Texas Commission on Environmental Quality

**RE: Response to TCEQ NOD4 E-Mail Dated 9 September 2024; MSW Tracking No. 29838265
Application for Development Permit for Proposed Enclosed Structure
Texas Star Property West, 11450 Trinity Blvd, Euless, Tarrant County, Texas 76040
MSW Authorization No. 62054; VCP No. 3237; RN100729763; CN604539007
SQE PN: 1098.015.003**

Application for Development Permit for Proposed Enclosed Structure Over Closed Municipal Solid Waste Landfill

Facility Name: Texas Star Property West

FIGURE 1**POOL LINER SECTION DETAIL**

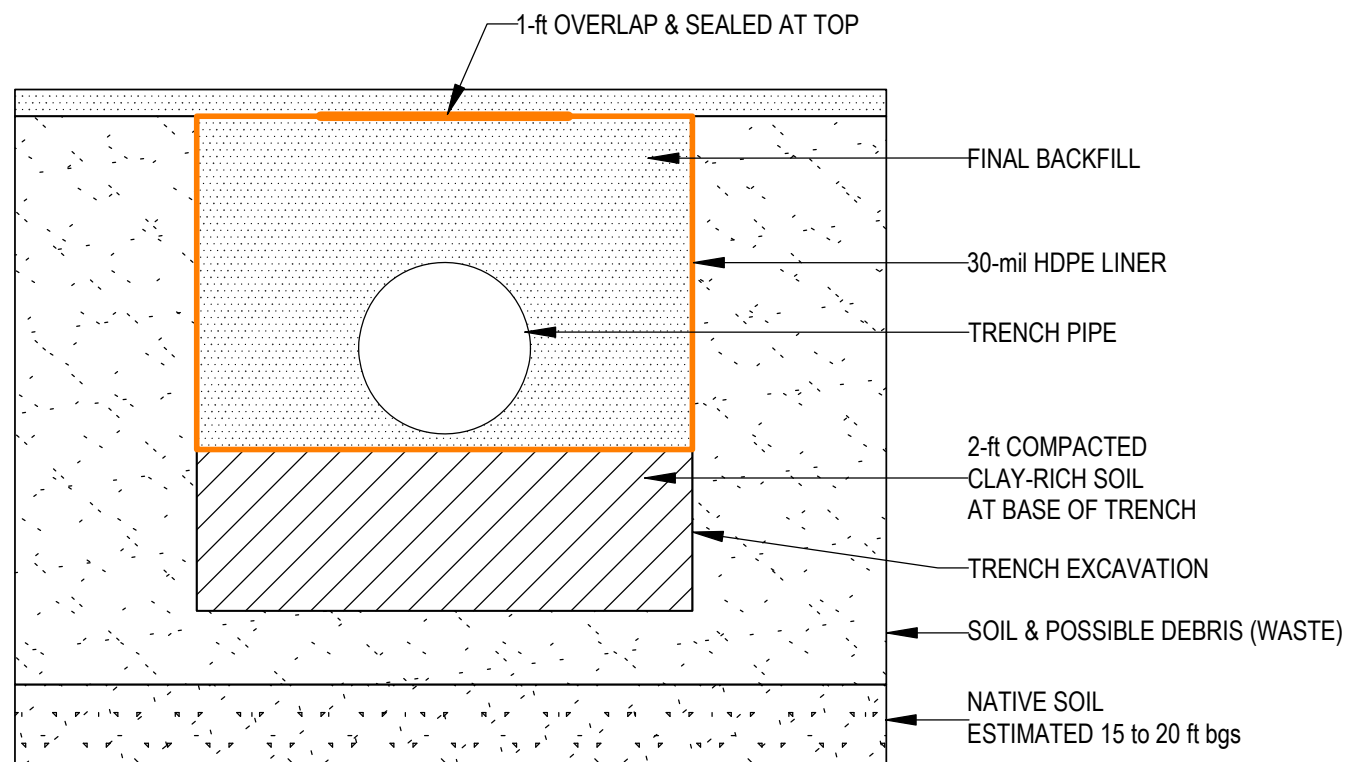
TCEQ Comment 6: Provide pool cross section(s) that include depiction of the sides of the pool details.

a) Explain in Attachment 9 how the topsoil protective cover will remain in place on the sidewalls during pool construction.

b) Explain in Attachment 9 how the topsoil protective cover will support the water-filled pool.

Response to Comment 6: Topsoil will no longer be used in the construction of the pool. The swimming pool will be lined with a HDPE 60-mil sealed geomembrane liner over at least 2 ft of compacted, clay-rich soil with a permeability not greater than 1×10^{-7} cm/sec. Clean fill will be installed under and on the sides of the pool. Revision 4 replacement pages for Sections 1 and 9 of the Application, including a revised Figure 1 of Attachment 9, are provided with this letter.

FIGURE 2**UTILITY TRENCH SECTION DETAIL**

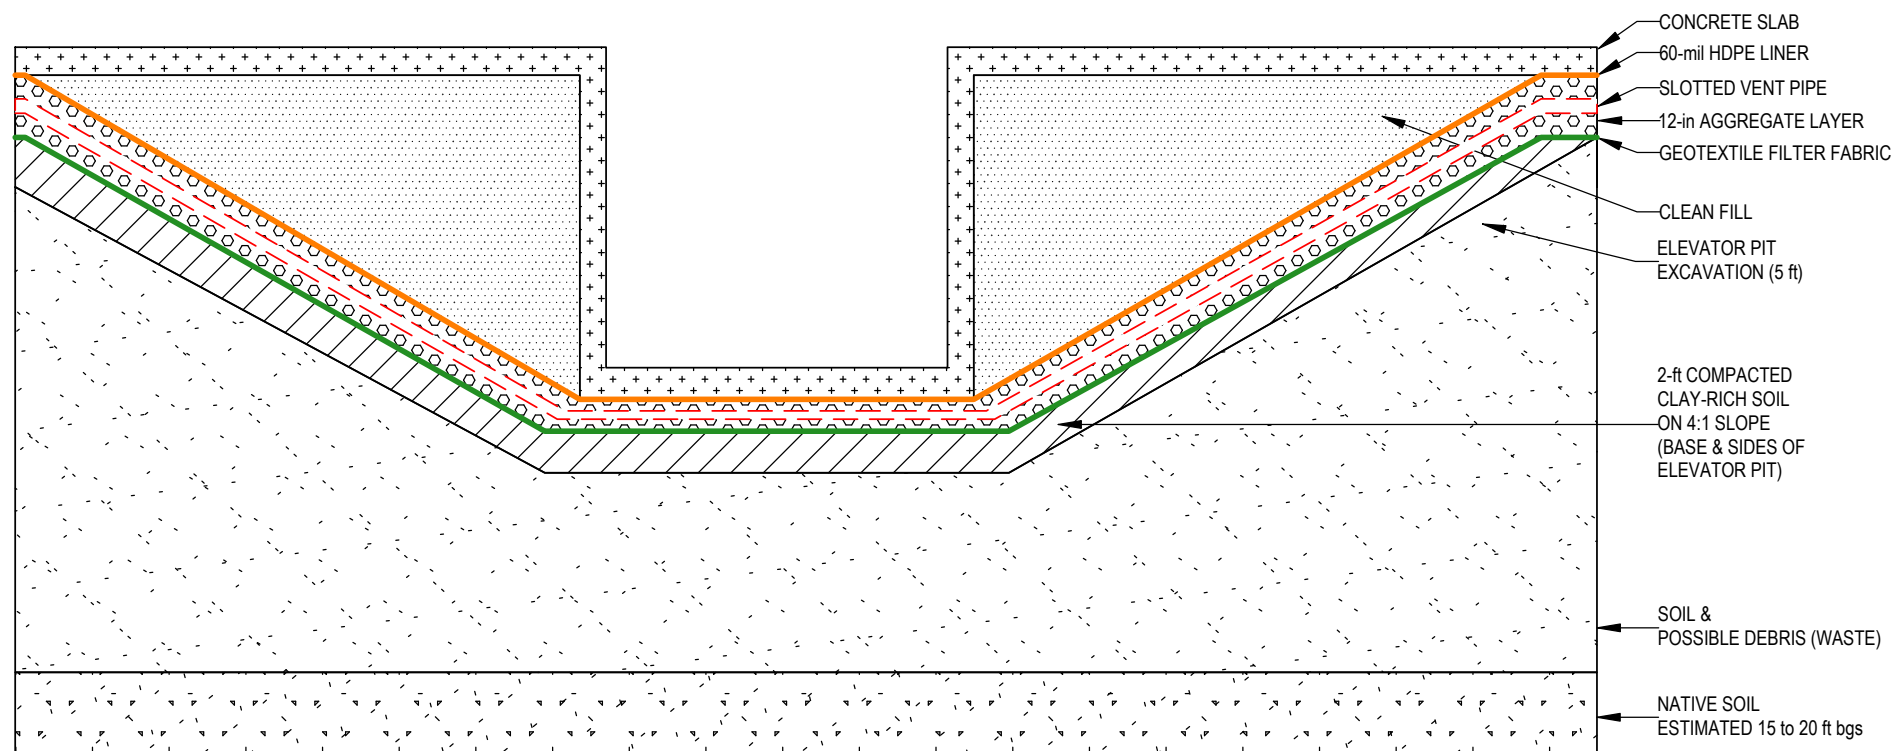
***TCEQ Comment 2:** Conduits carrying fluid which use the lined trench method need to have two feet of compacted clay on the bottom and sides of the trench underneath the geomembrane. Please revise Attachment 2 Figure 2 and narratives describing conduits carrying fluids so that a trench is excavated, two feet of compacted clay are placed along the bottom and up the sides of the trench and then covered with a geomembrane.*

a) *Clarify in the figure notes that storm sewer lines will also have double containment.*

Response to Comment 2: As discussed in the meeting between SQE and TCEQ MSW Permits on 11 September 2024, based on discussions with the project construction contractors, it is not feasible to install

2 ft of compacted clay on the sides of the trenches, as there is no way to compact the clay horizontally. The bottom of the trench will be covered with 2 ft of compacted clay, followed by an HDPE 30-mil liner installed on the bottom and sides of the trench. The conduit for carrying fluids will then be placed above the HDPE liner in the trench and clean backfill added to the sides. The HDPE liner will extend approximately 1 ft on top of the trench, be overlapped, and sealed. The note on Figure 2 of Attachment 9 has been clarified to state that the storm sewer lines will also have this same double-containment. Revision 4 replacement pages for Sections 1, 9, and 12 of the Application are provided with this letter.

GRASS/LANDSCAPED AREA MAP

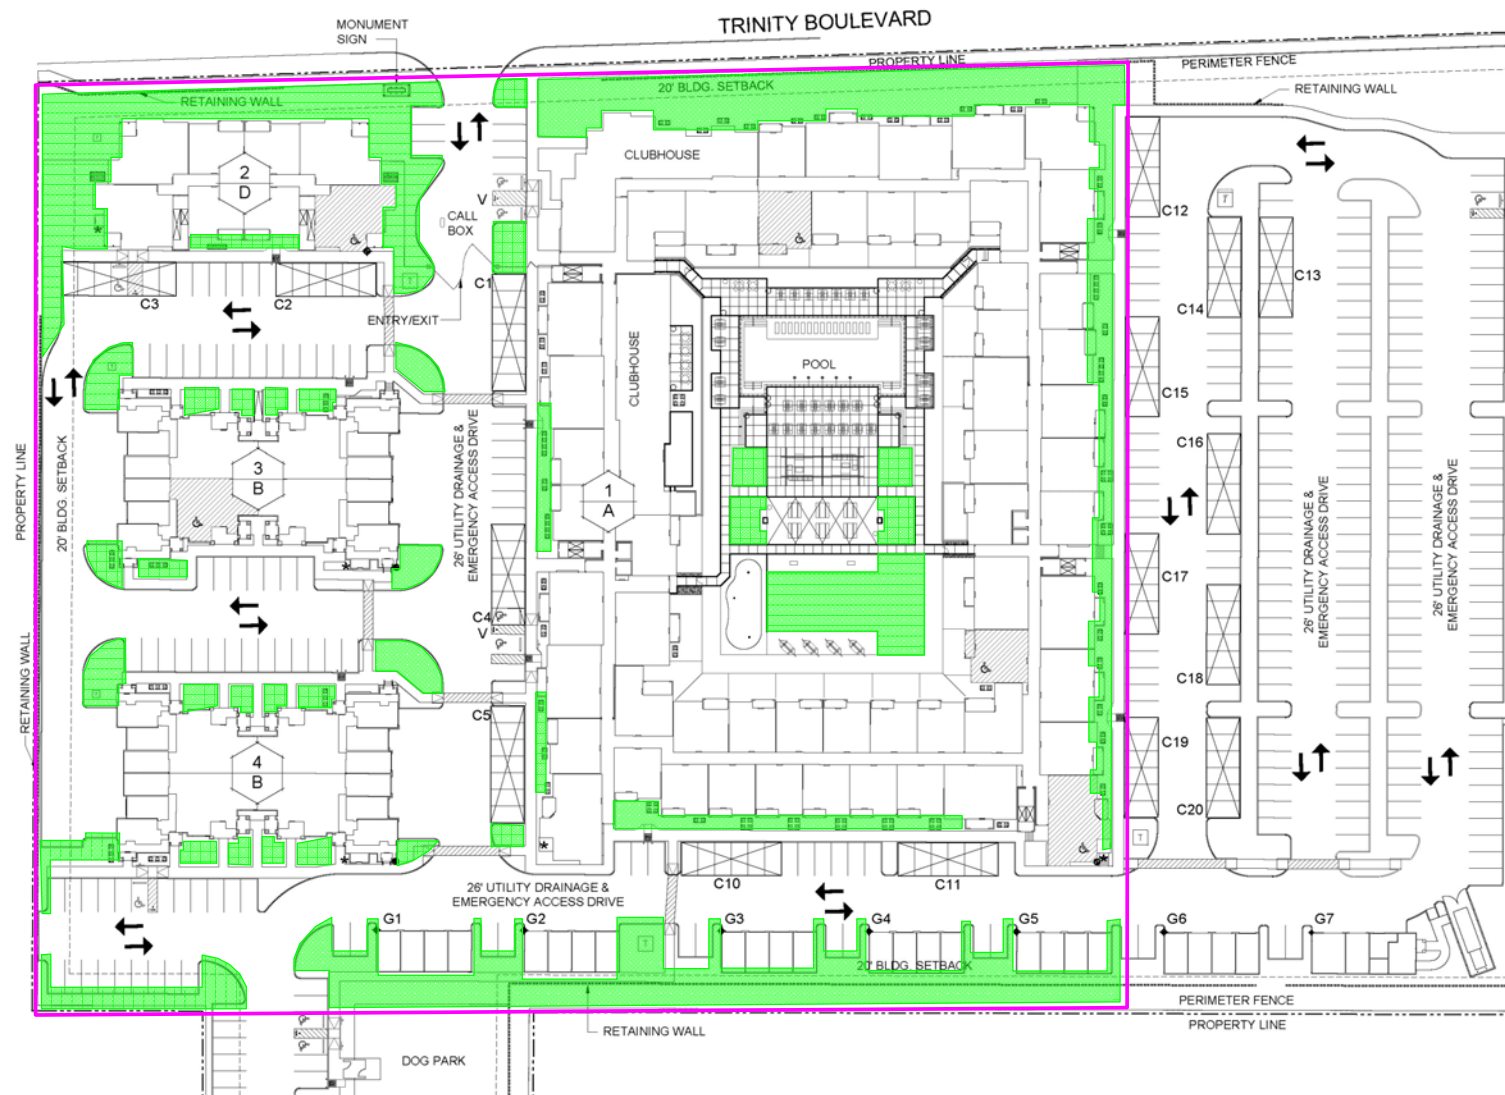
TCEQ Comment 4: Provide a Closure plan to ensure two feet of cover is provided. Please demonstrate that there is no waste within two feet of the soil disturbance in areas where there will not be buildings or pavement, e.g. courtyards, grass, and landscaping, or provide a final cover meeting the requirements of 30 TAC 330.453(a) and (b) in accordance with 30 TAC 330.957(q). Review and revise Attachment 11 as necessary.

Response to Comment 4: The Closure Plan in Section 11 has been revised. Eighteen inches of compacted clayey soil that is free of waste and 6 inches of topsoil will be present in areas of soil disturbance that are not covered by buildings, asphalt, or pavement. Revision 4 replacement pages for Section 11 of the Application and an added Figure 1 of Attachment 11 showing the grass/landscaped areas are provided with this letter.
